Report: TAB Report
Function: Test, Adjust, & Balance
Date: 03/13/2026
Completed By: National TAB

PROJECT
01-19-26 QT #1431 TOLLESON, AZ

Project: 01-19-26 QT #1431 TOLLESON, AZ

Project Issue Information

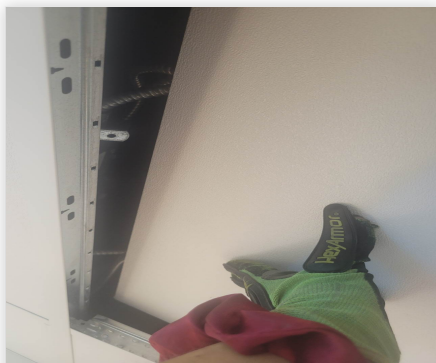
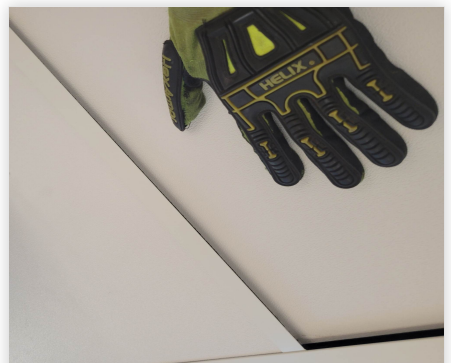
Issue Name : INACCESSIBLE KITCHEN DAMPERS
Description : Ceiling tiles can't be raised at all. Pics show 3 different tiles I tried to raise and how far I was able to move them. QT #0497 and plenty of others don't have this issue. Recommend either: light canisters need to be moved, duct plenum needs to be raised, or grille-facing dampers need to be used instead. MC should make sure dampers are accessible.
Created By : National TAB **Assigned To :** National TAB - Dan Hertenstein
Status : Open
Priority : High **Asset Tag :** RT-3
Originated Date : 01/20/2026 - Christine Weale - National TAB

Notes:

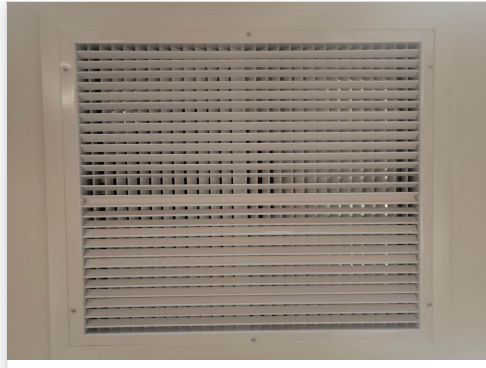
PICS OF GRILLE SHOW BEFORE AND AFTER. WHEN SET TO MSET DEPICTION, SMOKE LOSS WAS EXTREMELY HIGH MID-HOOD. HAD TO SET GRILLES ALMOST COMPLETELY OPPOSED TO HOOD TO OBTAIN 98% CAPTURE.
